# UNITED STATES NUCLEAR REGULATORY COMMISSION

ADVISORY COMMITTEE ON REACTOR SAFEGUARDS  
SUBCOMMITTEE ON GESSAR II AND  
RELIABILITY AND PROBABILISTIC ASSESSMENT

DATE: THURSDAY, FEBRUARY 14, 1985

The purpose of this meeting will be to continue to review the application of the General Electric Company for a final design approval that can be applied to future plans referencing the GESSAR II concept the BWR/6 Mark III Nuclear Island.

Figure 2-2. Comparison of the GESSAR II best-estimate hazard curve to the results of other seismic hazard studies.

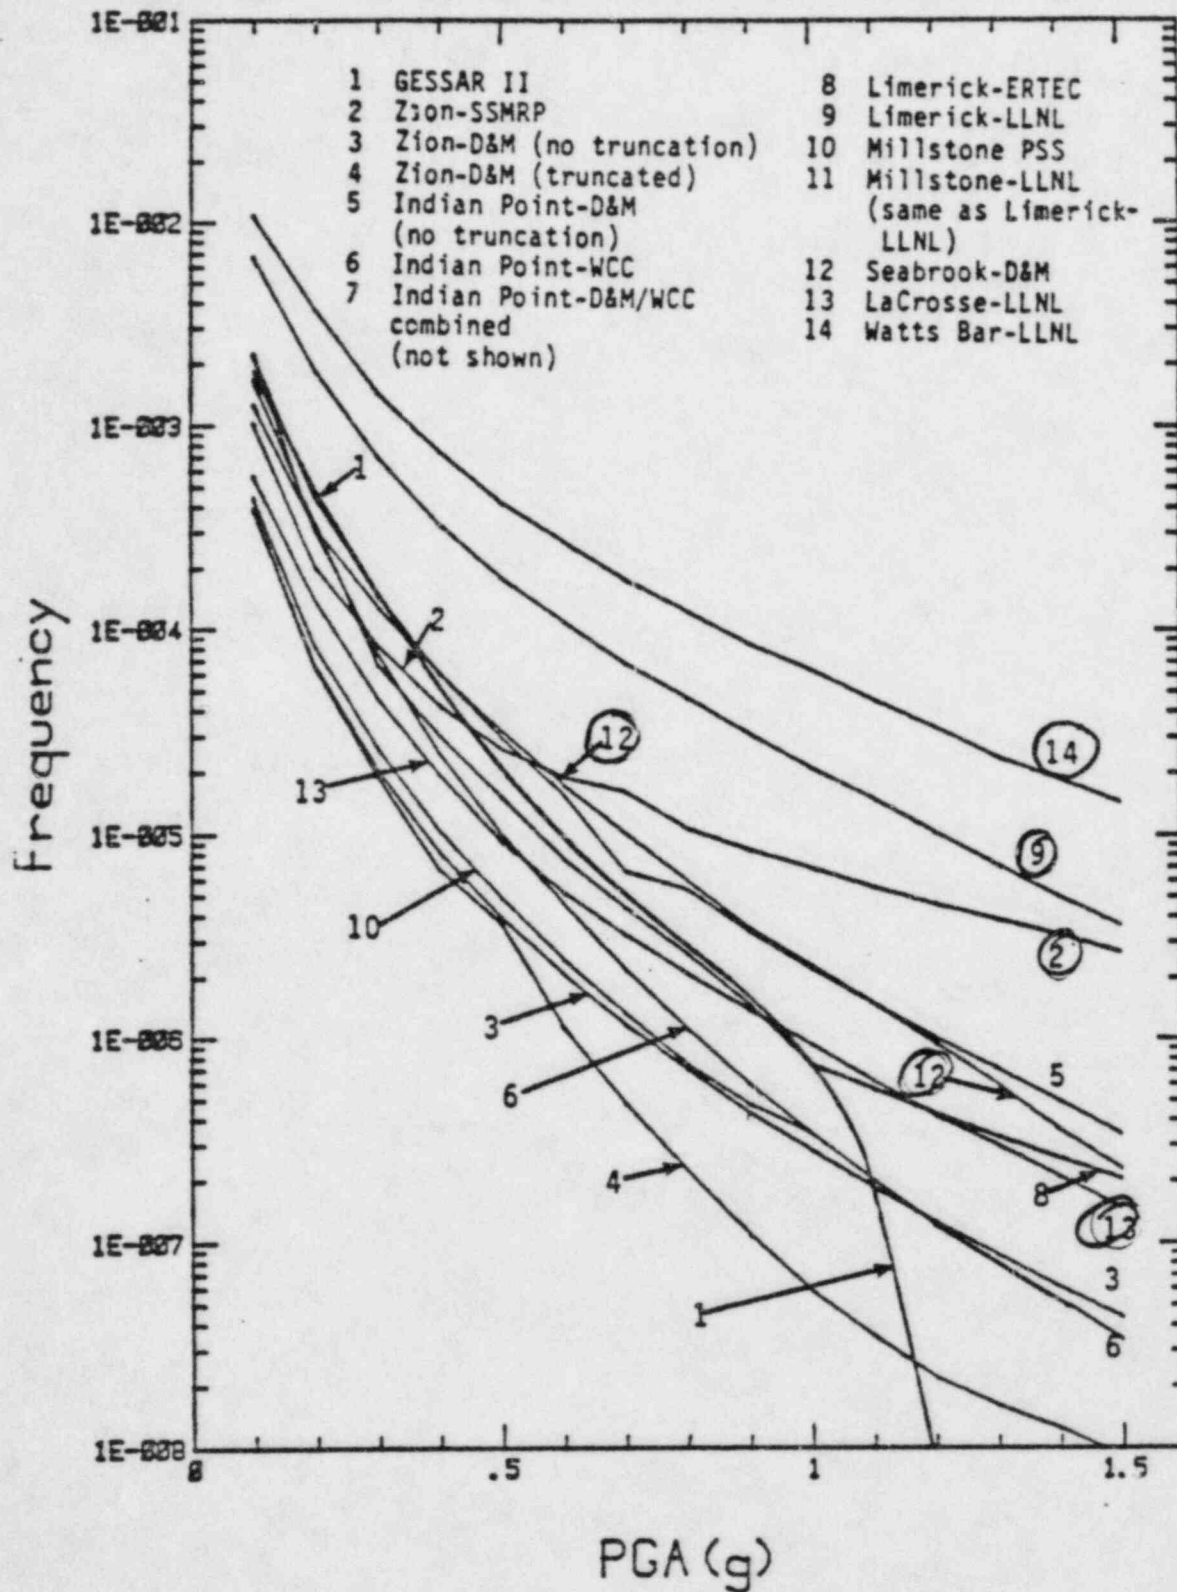
8 Whose  $10^{-8}$  value do you have in mind? I mean,  
9 I have seen that curve and it is not clear to me on what  
10 basis you are planning to establish that, going up to a  
11  $10^{-8}$  seismic event.

2 I understand very much what they mean by  
3 deciding to go off at  $10^{-8}$ . That is not my question.

11 So, we did look at existing PRA's and those  
12 are the curves that you see plotted on this figure. We were  
13 not intentionally trying to bracket all of them, although  
14 we effectively did with, at least of these three or four  
15 studies.

17 MR. HOLTZCLAW: The next curve, though, shows  
18 some information that was made available through the SSMRP  
19 program, shortly after GE submitted their report to the  
20 staff, and does show a much higher variability in seismic  
21 hazard curves.
